FIELD CHANGE ORDER

NUMBER: FT810-0001

This "O" coded FCO should be installed on ALL VAXft 810 shipped thru March 1994, upgrading all Revision "D" and "E" ATM boards to Revision "F". This FCO incorporates the following ECO's: (1) 5421083-BXB02, (2) 5421083-TWO003, and (3) 5421083-TWO004.

=====
This rework procedure gives step by step instructions on how to replace the flash ROMs for the V1.3 and V1.4 firmware upgrade of the I/O ATM module, (5421083, KD560-AA), for the VAXft 810 system.
+++++

FT810-0001

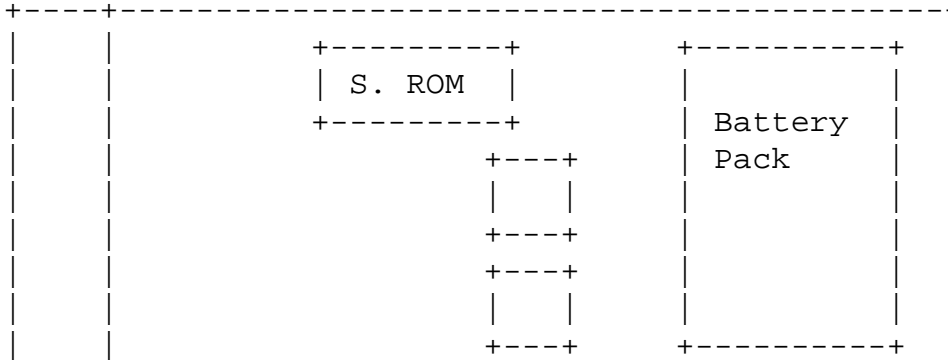
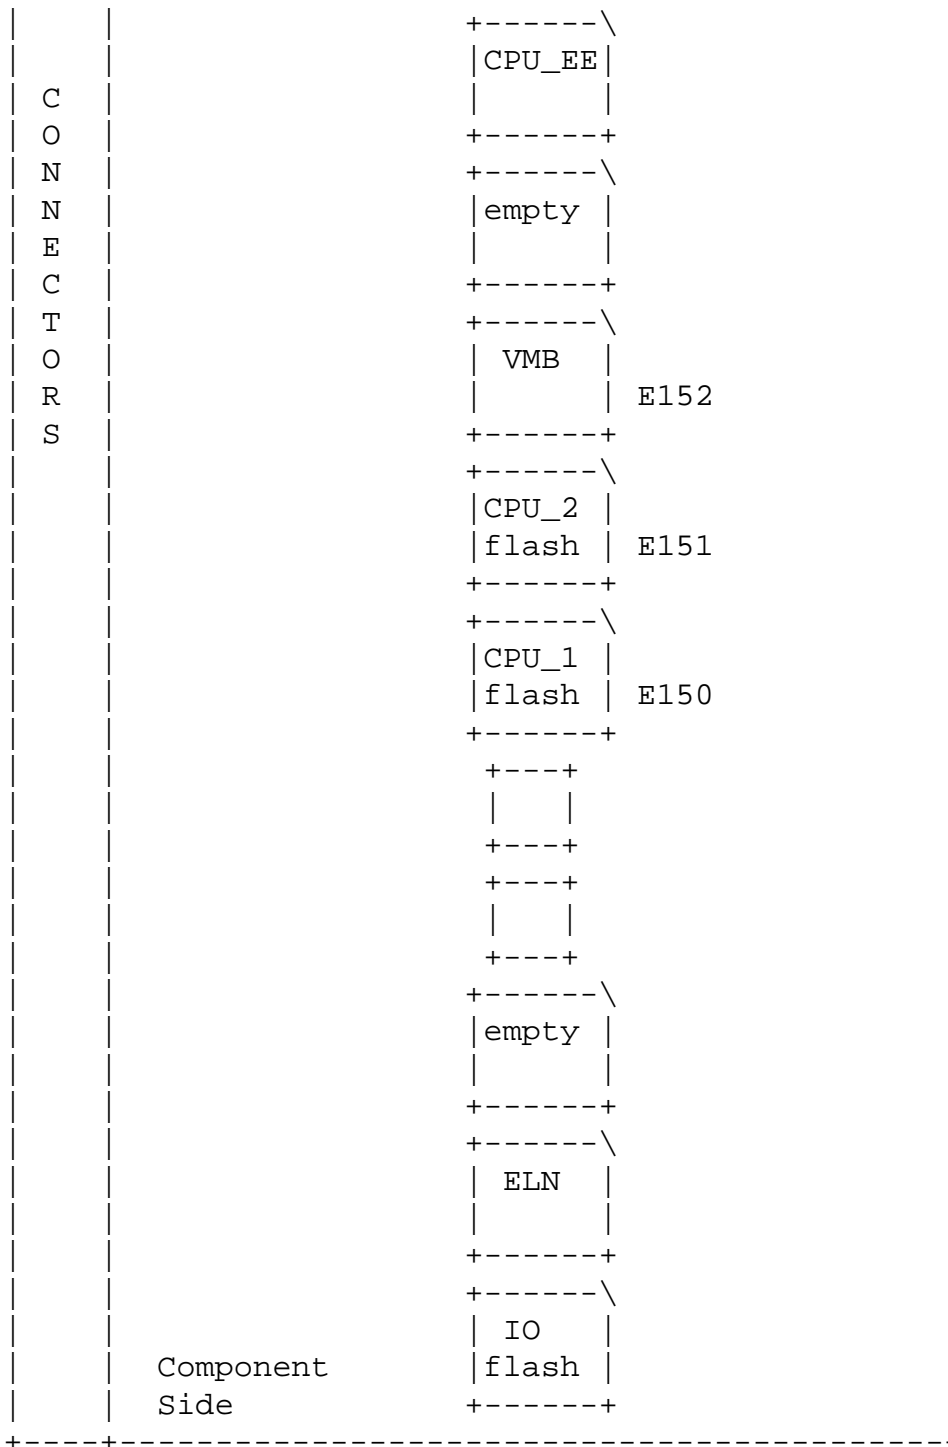
4.4 Place new part number 23-0006Z4-00 (V1.1 VMB) gently "on" the socket orienting the pin 1 designator, (single dot depression on slanted upper surface, see Attachment#1), facing toward the module handle. Verify that the beveled corner is oriented toward the corner of the module where the battery pack is mounted.

4.7 Place new part number 23-0037Z4-00 (V1.4 CPU_1) gently "on" the socket orienting the pin 1 designator, (single dot depression on slanted upper surface, see Attachment#1), facing toward the module handle. Verify that the beveled corner is oriented toward the corner of the module where the battery pack is mounted.

4.10 Place new part number 23-0036Z4-00 (V1.4 CPU_2) gently "on" the socket orienting the pin 1 designator, (single dot depression on slanted upper surface, see Attachment#1), facing toward the module handle. Verify that the beveled corner is oriented toward the corner of the module where the battery pack is mounted.
